PACIFICORP'S  
APPLICATION TO CONSTRUCT  
YREKA-WEED TRANSMISSION LINE UPGRADE PROJECT  
CPUC A.05-12-011

Final Mitigated Negative Declaration  
SCH #: 2006092006

**Subject: NOTICE OF AVAILABILITY OF A FINAL MITIGATED NEGATIVE DECLARATION –  
PacifiCorp’s Yreka-Weed Transmission Line Upgrade Project (A.05-12-011)  
SCH# 2006092006**

PacifiCorp's Yreka-Weed Transmission Line Upgrade Project . 205439  
**Figure 2.4-3**  
 Sand Hill Crane Nest and Mitigation Areas

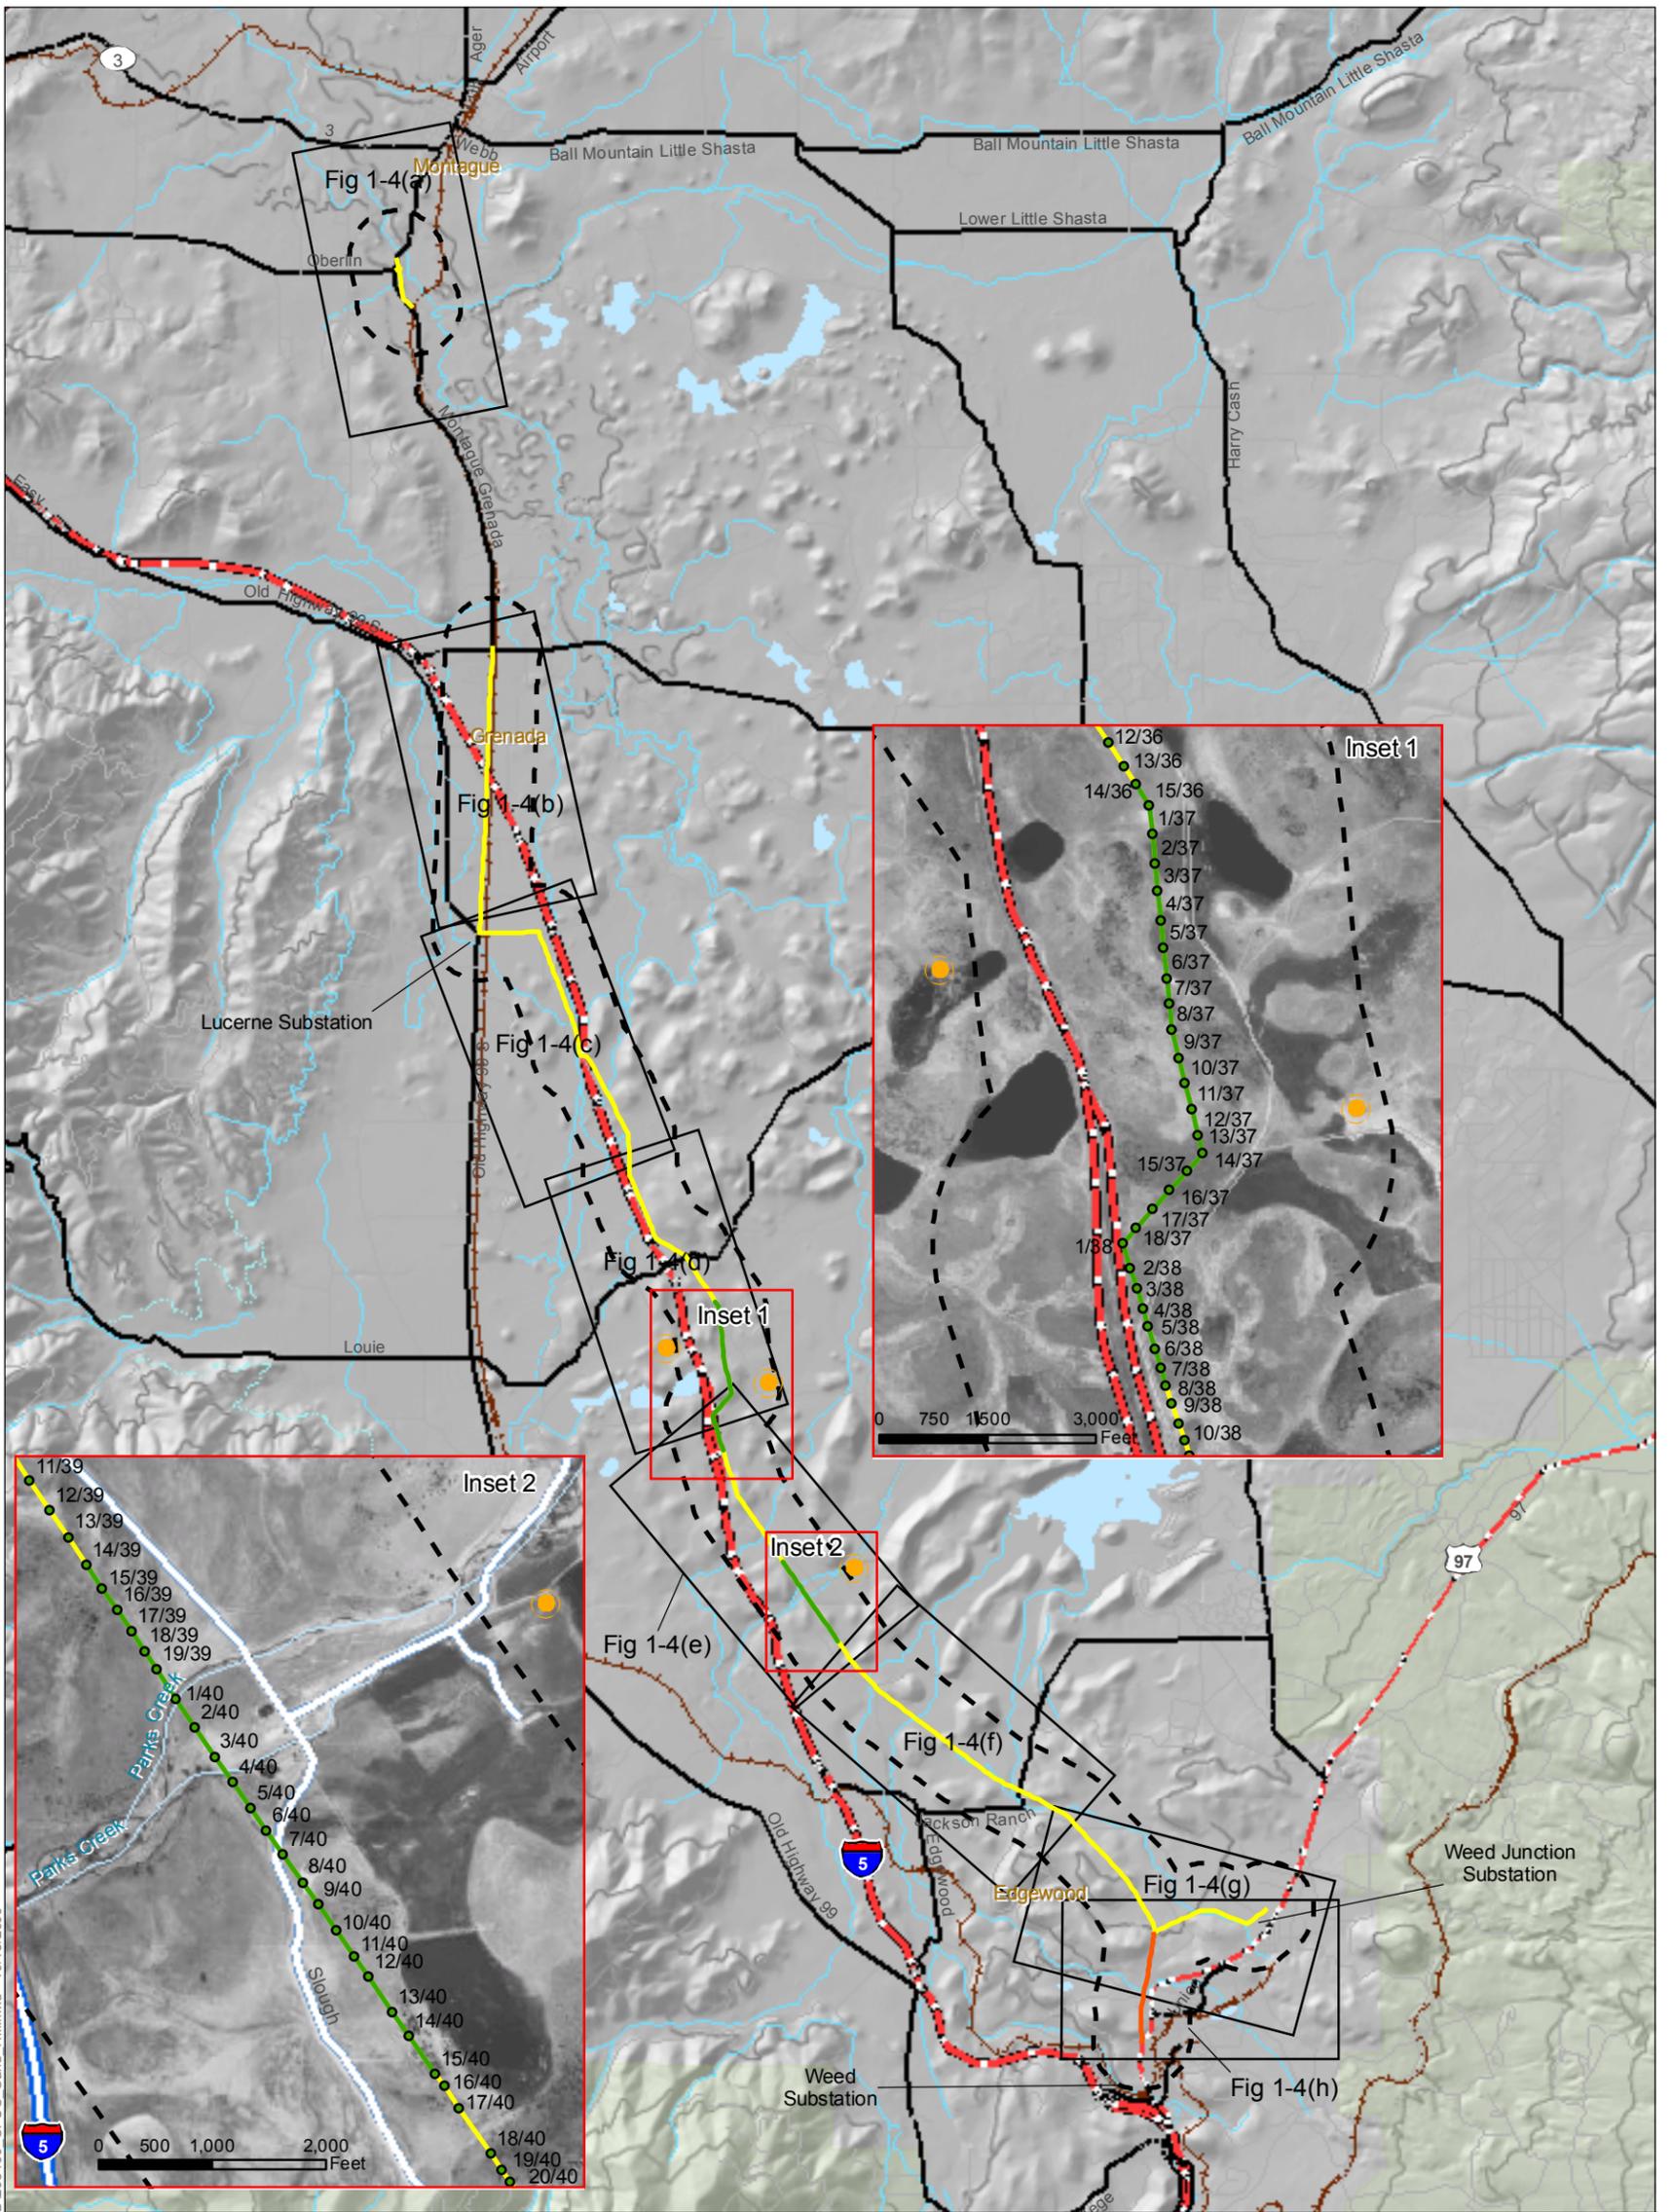
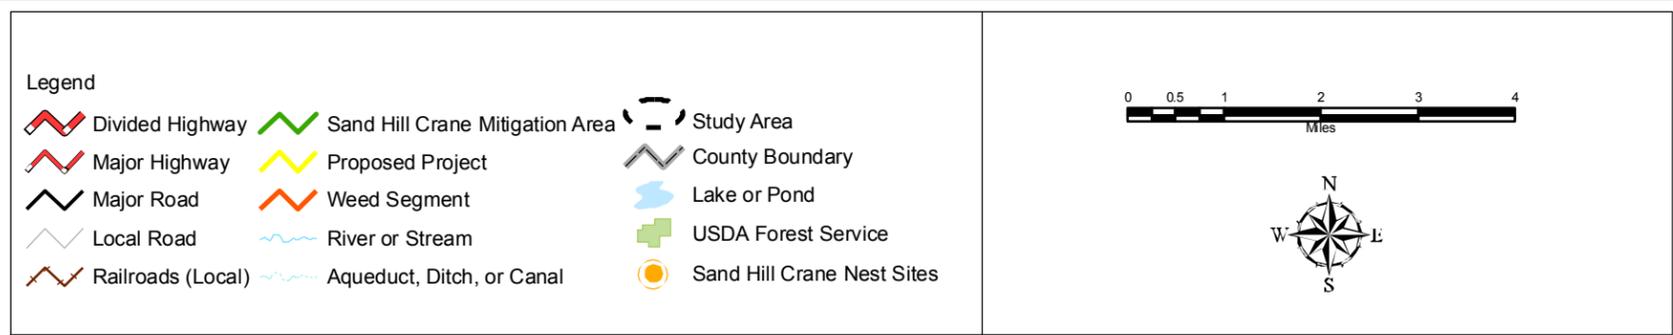
Another example of the lack of information relates to Swainson's Hawks. There is no discussion as to whether the species is prone to collisions with power transmission lines. The MND refers to Figure 2.4-3 for information about known nest locations. However, this figure is not in the document.

**Mitigation Measure 2.4-8:** PacifiCorp shall install warning markers (e.g., yellow aviation balls) on the upgraded transmission line one-half mile north and south of the point along the transmission line ROW closest to the known nests (i.e. Pole 14/36 south to Pole 8/38 and Pole 14/39 south to Pole 15/40). The known nests and recommended marker locations are shown in Figure 2.4-3. The specific marker type and

Note, although Figure 2.4-3, included within this document, was inadvertently left out of the MND; the information depicted was used in the analysis of impacts to sandhill crane.
